COLD SPRING PLANNING & ZONING
May 14, 2025
6:30 PM

FILE NUMBER: PZ-25-006
APPLICANT: Bohler Engineering
LOCATION: Alexandria Pike at Cold Spring Pointe
REQUESTS: Stage I and Stage II Plans for a Financial Institution with a Sign Variance

FILE NUMBER: PZ-25-018
APPLICANT: Merus, LLC
LOCATION: 3725 Alexandria Pike
REQUESTS: Stage I and II Plans for a Restaurant

FILE NUMBER: PZ-25-019
APPLICANT: Merus, LLC
LOCATION: 3725 Alexandria Pike
REQUESTS: Stage II and Grading Plans for a Retail Development

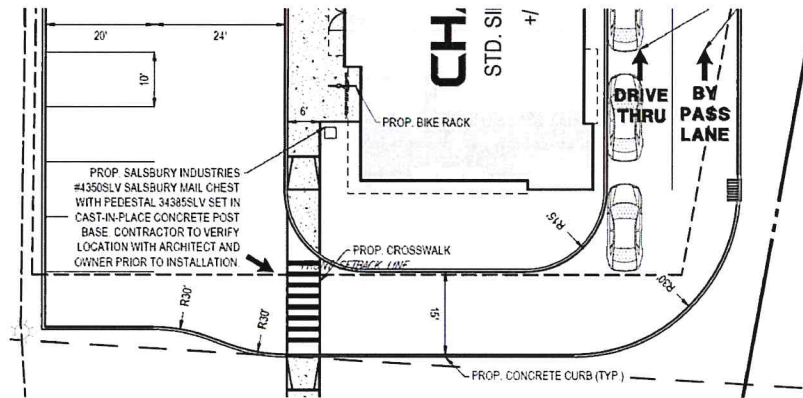
14. The location of all off-street parking, loading and/or unloading, and driveway areas is provided on Sheet C-302.

- Parking stalls are indicated as 10' by 20'. Drive aisles are indicated at 24 feet within the parking area.
- The one-way drive aisle to the drive-thru lane narrows to 15' before widening back to 24' for a bypass lane.

SITE PLAN
SCALE: 1"=55'-0"

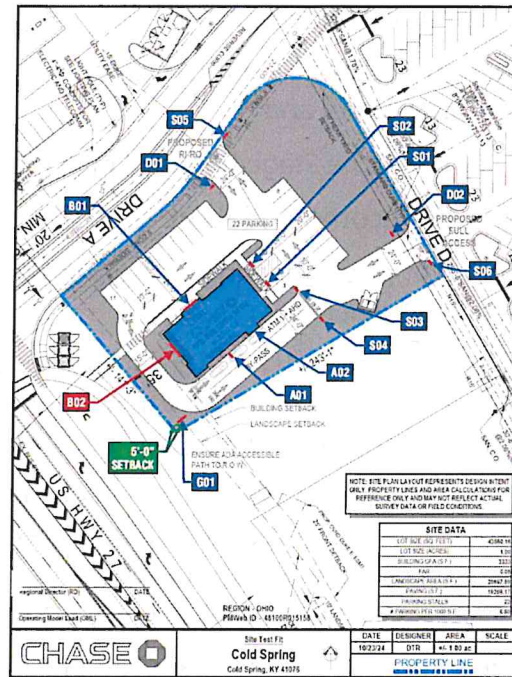
7. Among the signage proposed, two (2) Class 5 signs are proposed: One on the southwest (SW) side facing Alexandria Pike (US27), and one on the northwest (NW) side facing Drive A. The access to the lot is from Drive A. The ordinance limits the number of class 5 signs to one per street frontage. Drive A is a private street and does not count toward permissible frontages.

8. In travelling Northbound on US 27, the proposed monument sign to the south of the building serves to identify the business location and, as it is approached, the wall sign on the SW elevation building identifies the building. The SW facing wall sign also serves to identify the building to people crossing US27 from the Meijer shopping center across the street. Traveling southbound, the wall sign on the NW elevation serves to identify the building. This sign also serves to identify the building to people coming from within the Cold Spring Point shopping center.

9. The applicant has indicated that the NW facing sign is their preferred location if only one sign is permitted. The monument sign at the southern point of the parcel faces northbound and southbound traffic directly. When directly in front of the building on US27, or travelling across the street from the Meijer shopping center, the NW facing signage would not be visible, nor would the sign face of the monument sign.

1. To grant a variance of the maximum number of Class 5 signs to allow for a total of two (2) class 5 signs; and
2. To approve the Stage I/Stage II plan for a bank with drive-through.

ARCHITECTURAL SITE PLAN
MERUS | **MERUS** | A1.1

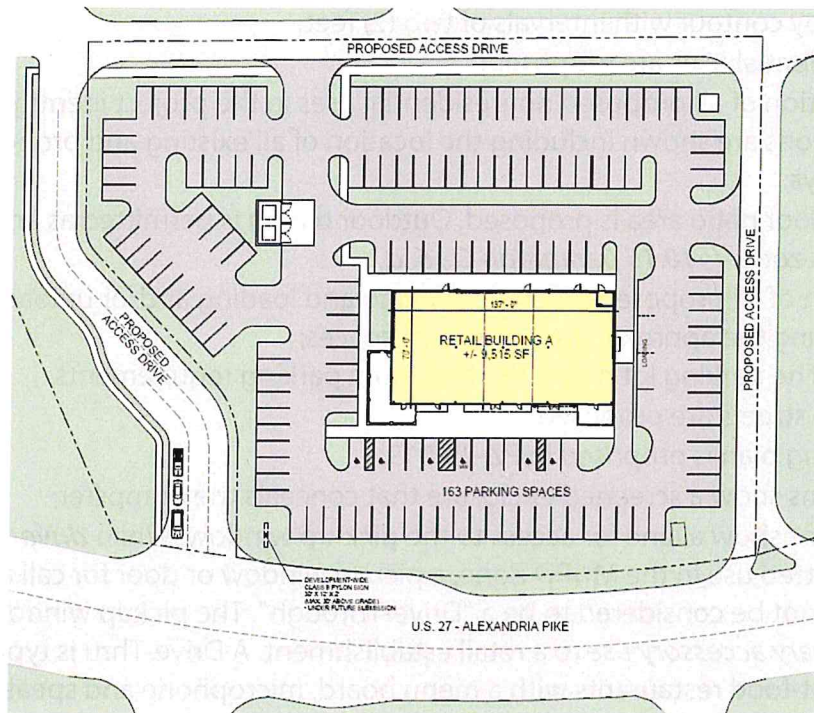
- No residential uses are proposed;
- Delineation of all proposed nonresidential uses in the project identifying approximate dimensions are shown including the location of all existing and proposed pedestrian walkways;

- An outdoor patio area is proposed. Outdoor dining is permitted as an accessory use in the SDA zone. (*§10.15 paragraph O., 6. c.*)
- Location of all proposed off-street parking and loading and/or unloading areas, identifying the approximate number of spaces;

- The parking lot meets the minimum parking requirements
- No new streets are proposed;
- A grading plan is proposed in PZ-25-019;
- The plans show a screened enclosure that conceals the dumpster;

- The plans show a lane for access to the pick-up window. While *drive-throughs* are not a permitted use in the MUPD Zone, a pickup window or door for call ahead orders should not be considered to be a "Drive-Through". The pickup window is considered a *customary accessory use* to a retail establishment. A Drive-Thru is typically associated with fast-food restaurants with a menu board, microphone and speaker system in a dedicated lane. Orders are placed and received while the customer remains in the queue lane. Noise and traffic are common concerns with conventional fast-food drive-throughs. Cold Spring has accepted pickup locations at LaRosa's, and O' Charley's as examples. The City also has numerous grocery stores and pharmacies that use an order ahead pickup location. We recognize that this is an evolution that migrated from retail services (like a dry cleaner) to restaurants. Call-ahead ordering with a pickup location is a new normal.

- Photometric plan is provided;
- Circulation plan is provided.
- The building is indicated as 9,515 square feet of gross leasable space.
- The plans indicate 163 parking spaces with 6 ADA-compliant spaces. For this building, the parking regulations would require:

- 38 spaces for retail and personal service use (4 spaces/1000 square feet); or
 - Approximately 159 spaces for a restaurant (1 space/2 employees at busiest shift plus 1 space/65 square feet of leasable space.

- The proposed 163 spaces exceeds the number of required spaces even if the entire development were to be occupied by eating and drinking establishments.

- Staff opines that the provided parking is more than adequate for a combination of retail and restaurant uses. Trip reduction regulations in Article 9 could be applied to reduce the required number of parking spaces based on nearby public transit.

To approve the Site Development Plan with the following condition:

- Stage II plans be submitted for review the City's engineer.
